No.	Date	Description
1	2025-09-19	Add No. 1
2	2025-09-30	Add No. 2

**WCFPD Station 3**  
**Wright City Fire Protection District**  
9 Highway WW  
Wright City, MO 63390

**ROOF FRAMING PLAN**

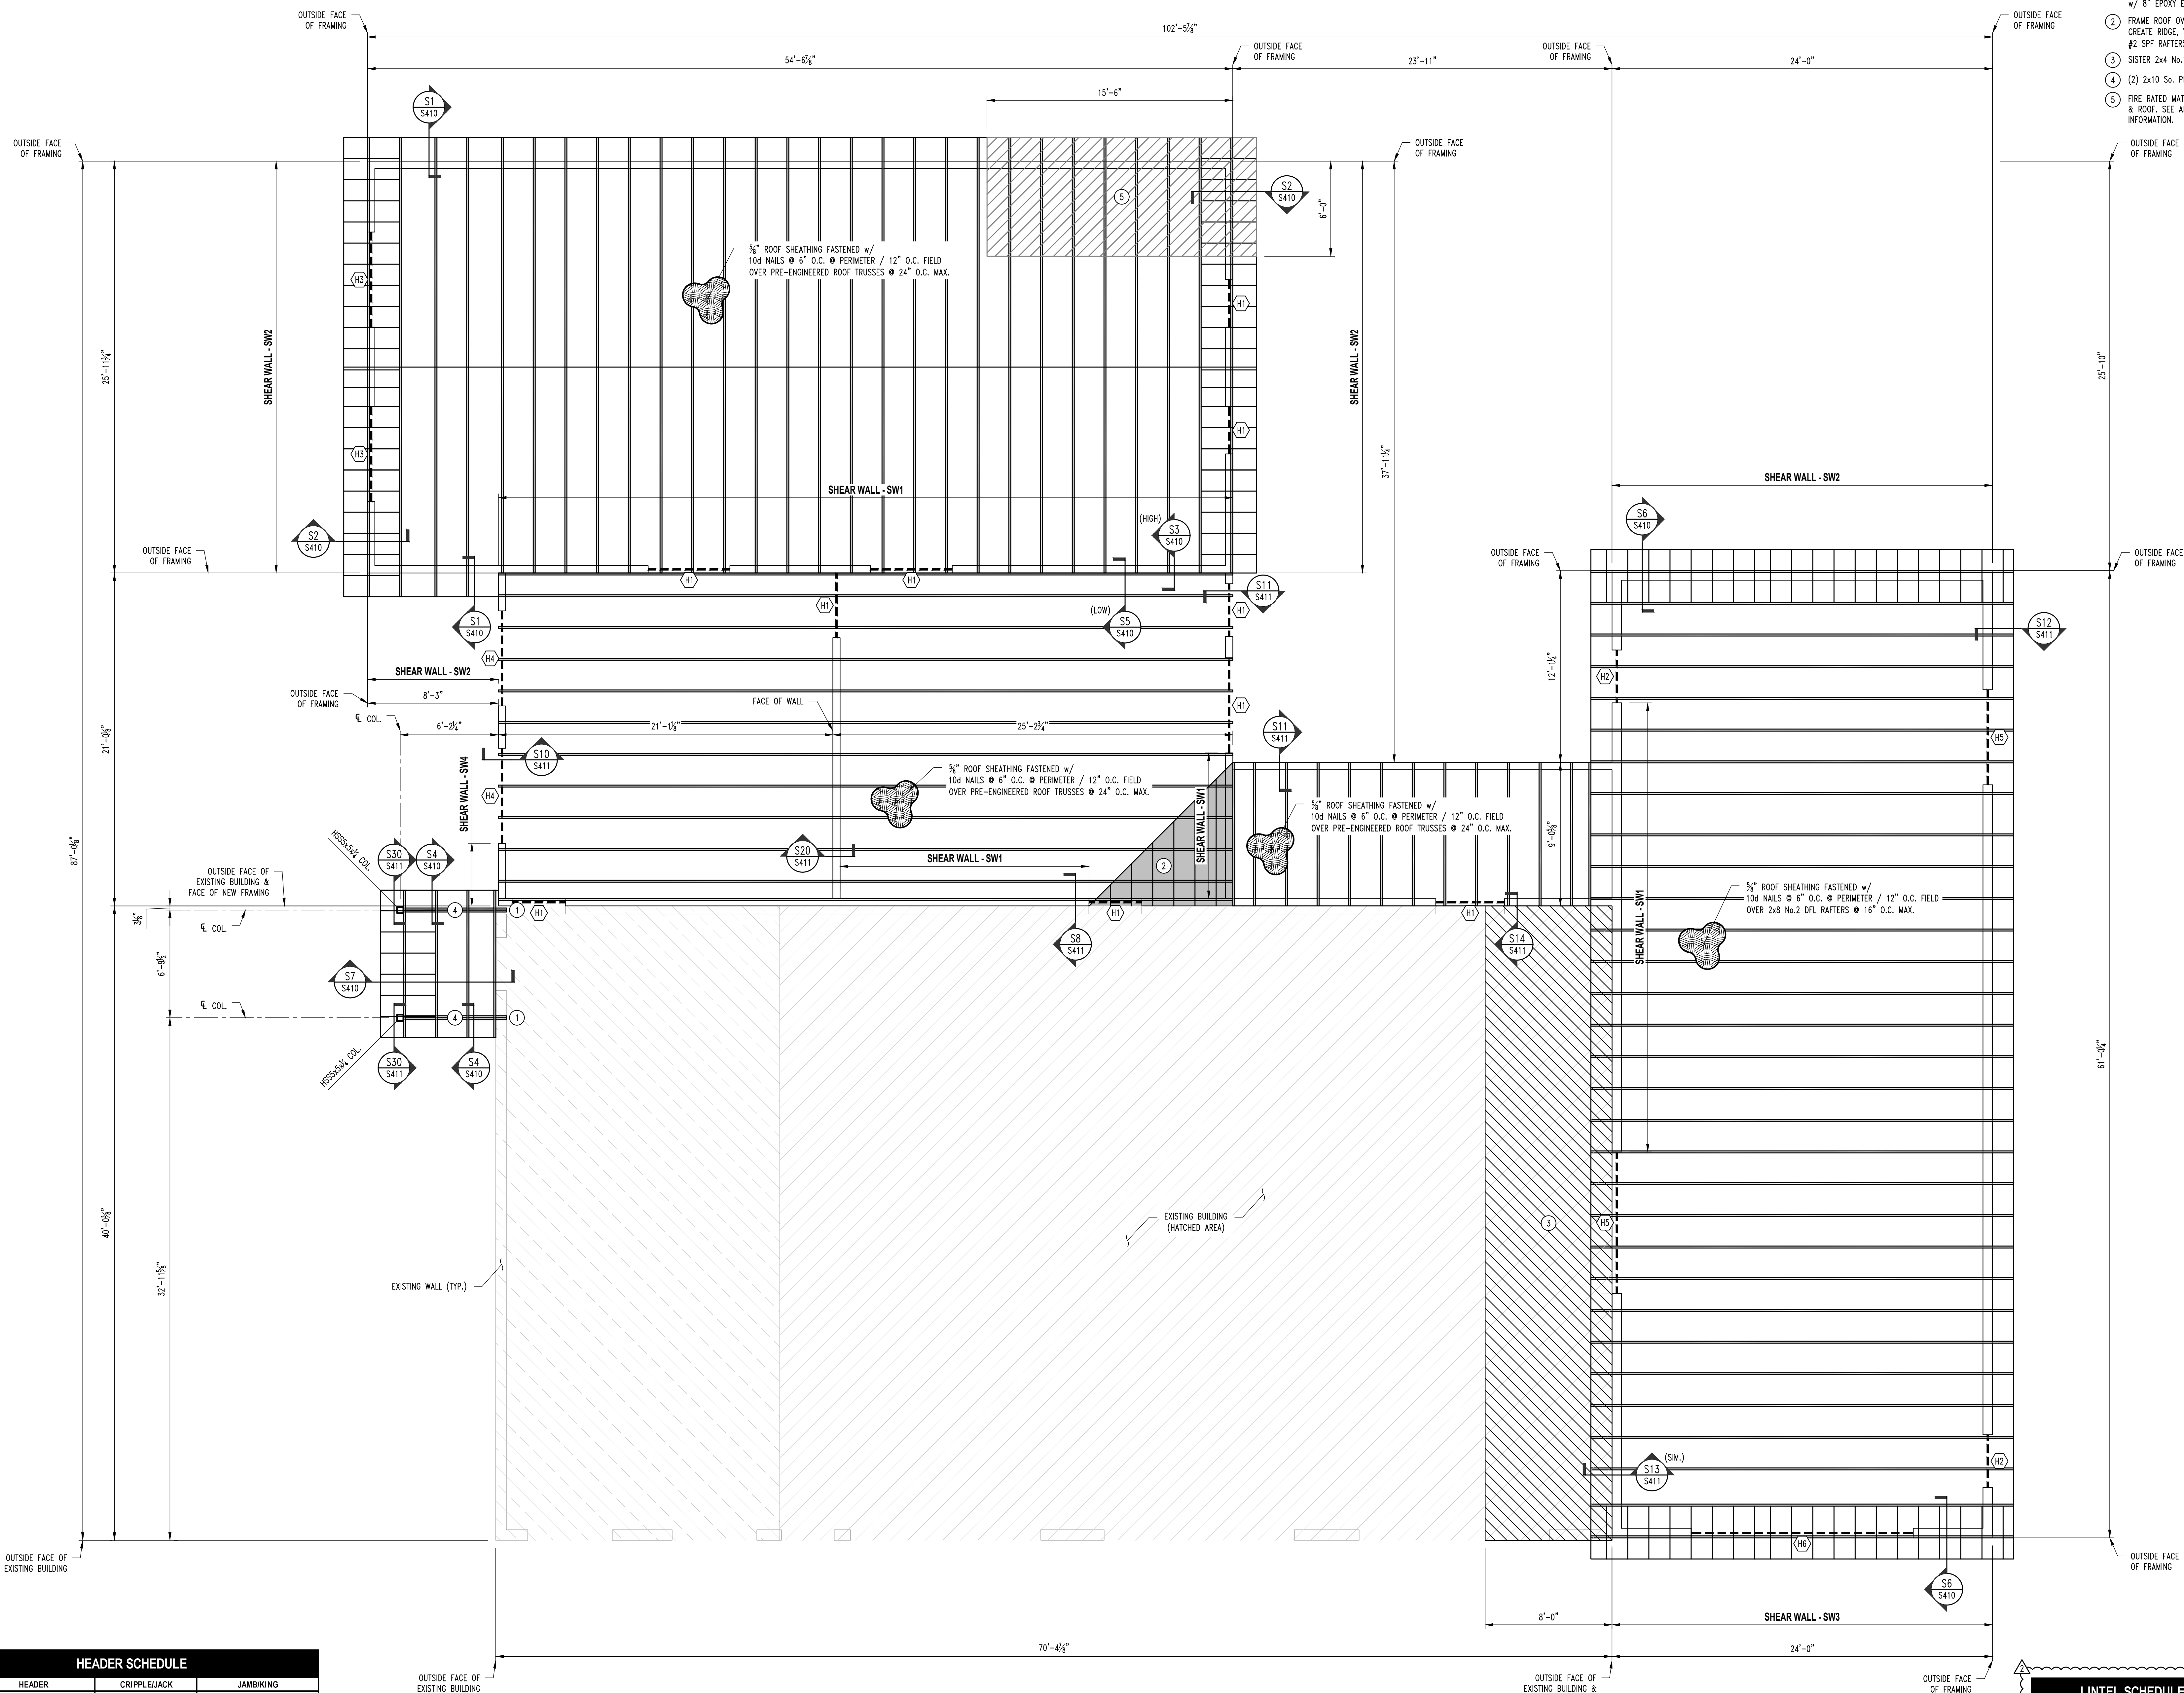
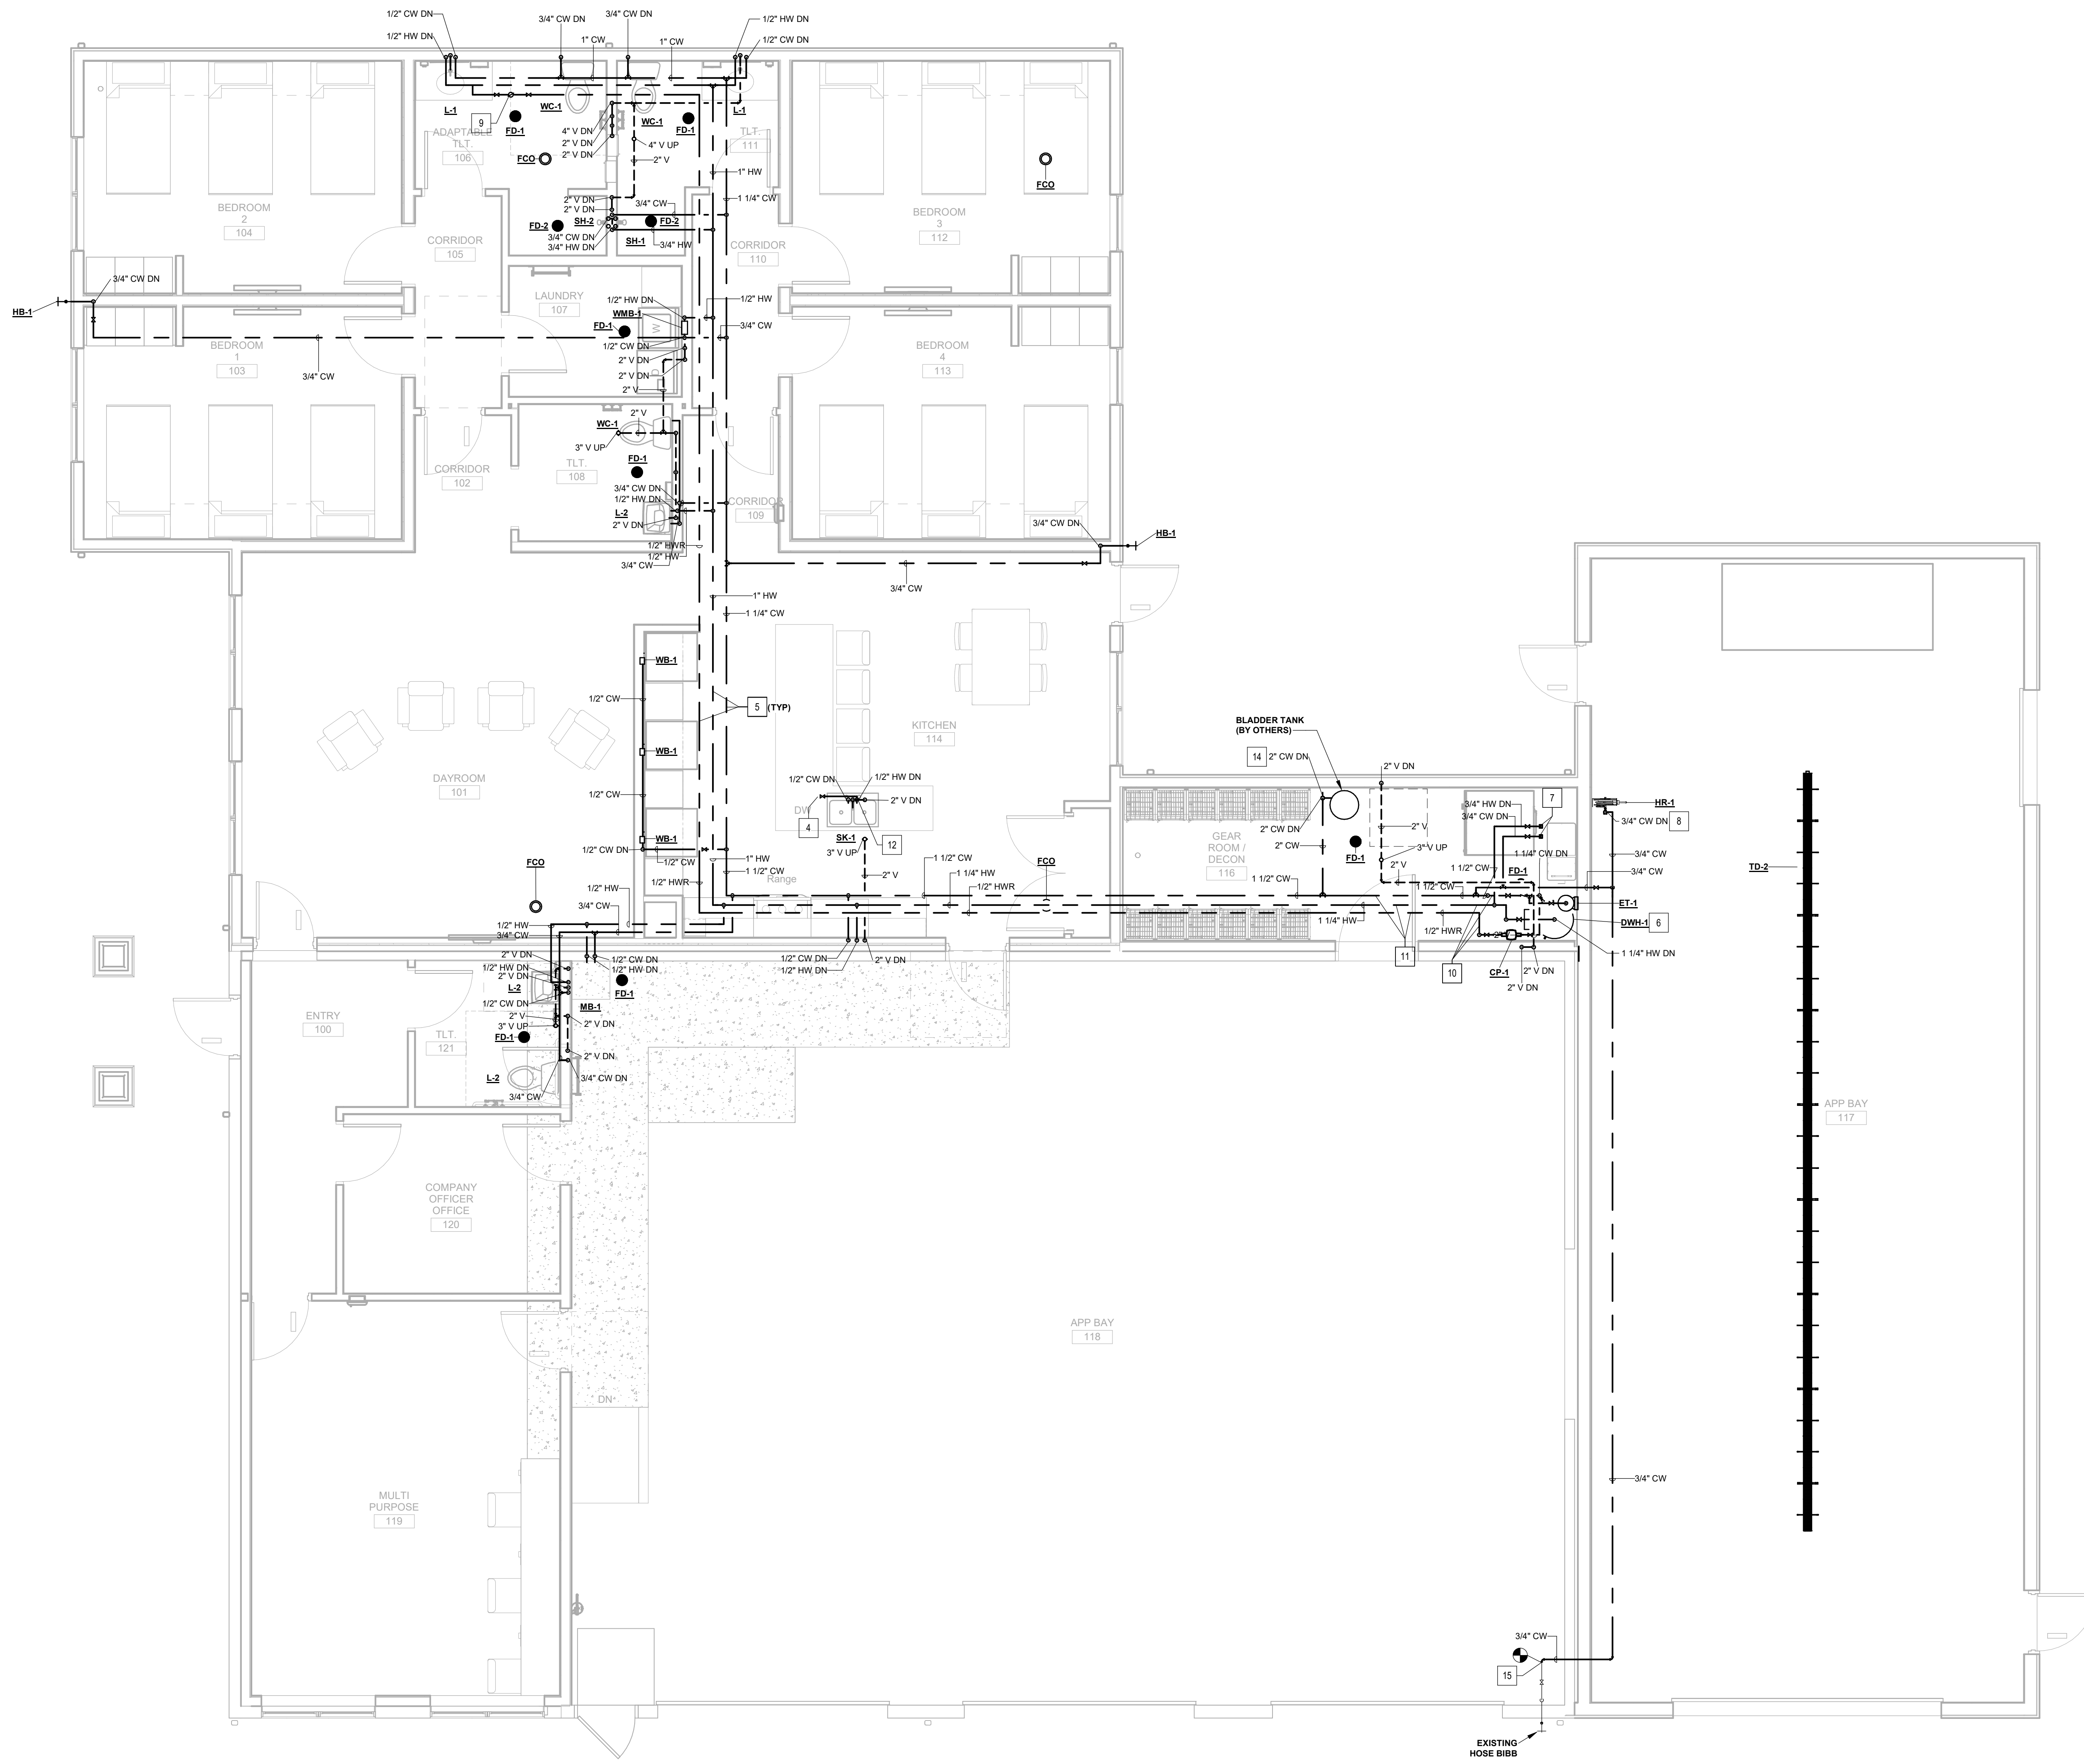
- 30) Sheet S400 – ROOF FRAMING PLAN
  - a. ADDED brick lintel schedule for Alternate.
- 31) Sheet P300 – FLOOR PLAN – ABOVE SLAB PLUMBING
  - a. REVISE Keynote #8 to add the following sentence, “INSTALL VACUUM BREAKER ON COLD WATER SUPPLY LINE TO HOSE REEL.”

**10 FINAL CONNECTION GAS WATER HEATER**  
M4.00 NO SCALE

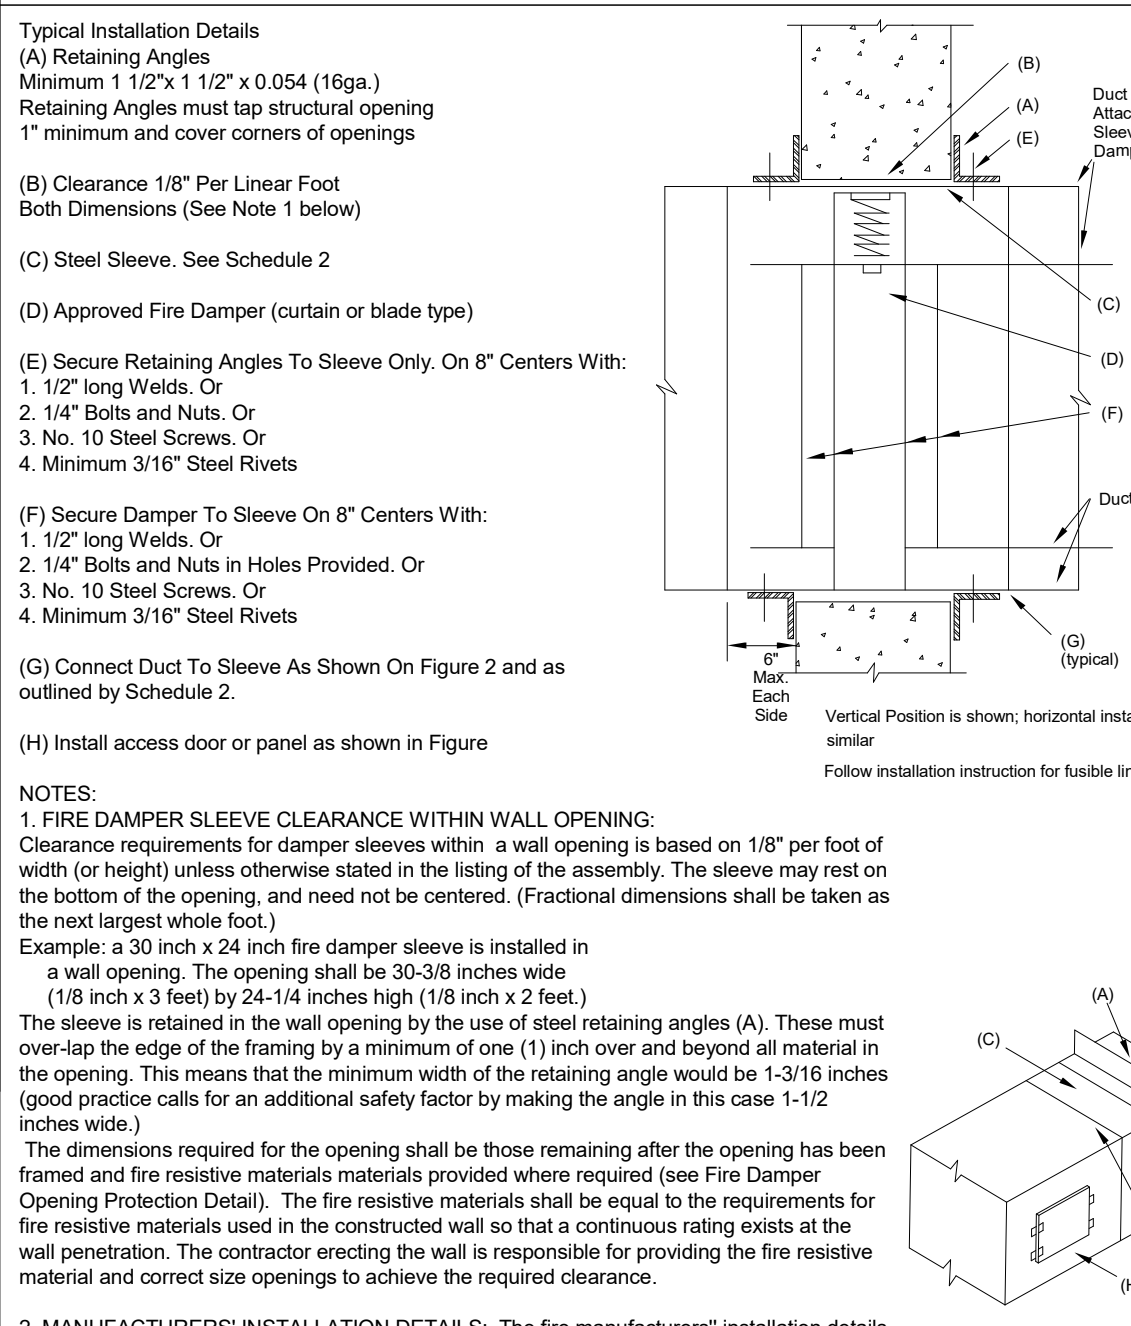
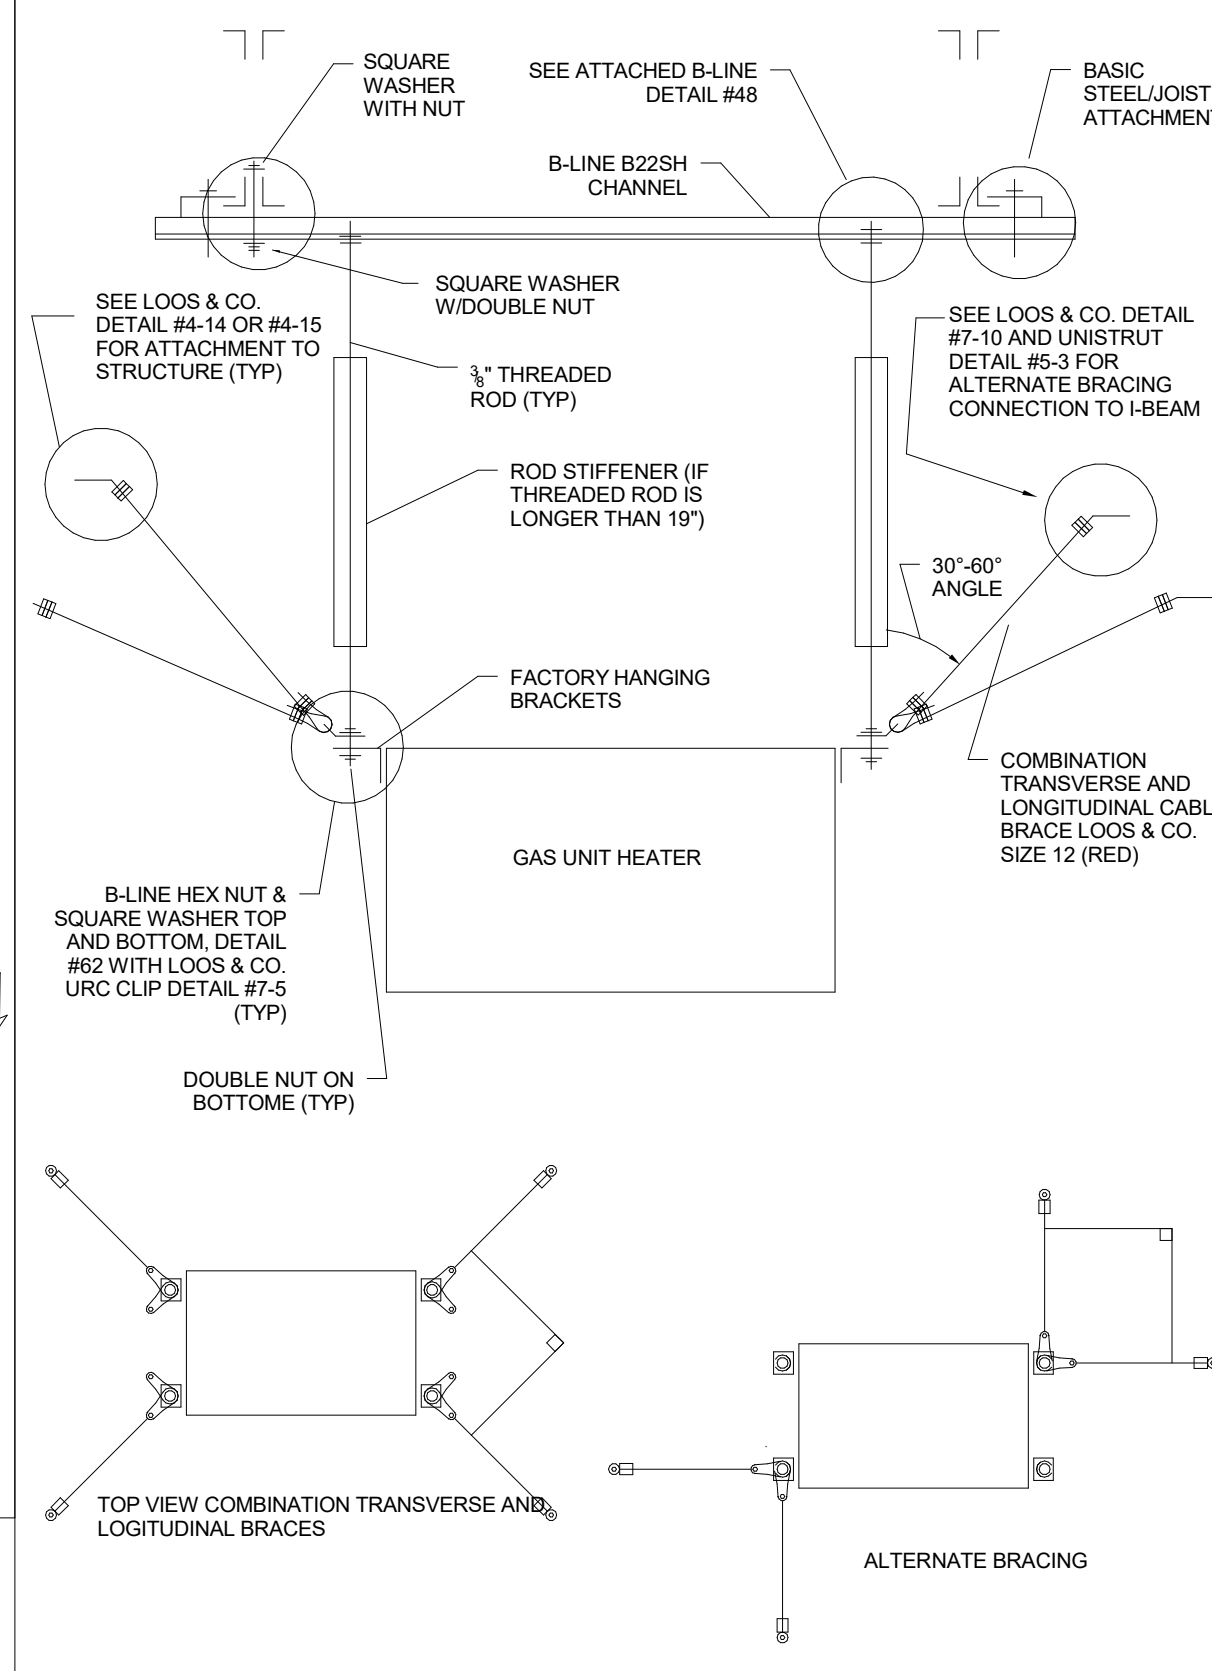
- b. ADDED Details 8 through 11.
- 36) Sheet M4.01 – SPECIFICATIONS
  - a. UPDATED Piping Specifications to include gas piping.
- 37) Sheet M5.00 – MECHANICAL SCHEDULES
